86100C-12

S E R V I C E N O T E

86100C Digital Communications Analyzer Mainframe

Motherboard board mounting modification improves product reliability related to boot up issues.

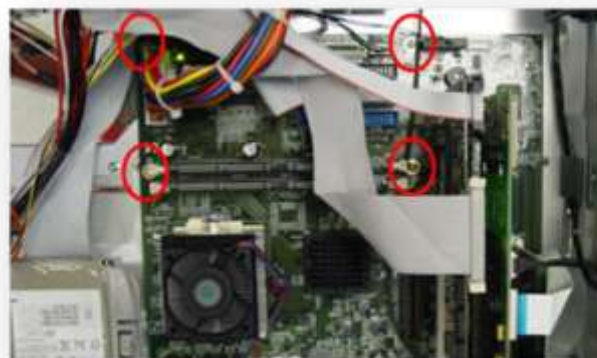
The most common symptom is a boot up error as shown here. The mainframe will come to the point where all LEDs are lighted but will not progress through the boot sequence.

This can be either a hard failure or very intermittent.

To verify the problem is related to the board flexing issue:

1. Power the instrument off and remove the cover.
2. Loosen the four screws indicated here.
3. Re-boot the instrument.
4. If it boots normally, then board flex caused by the foam is a likely cause.
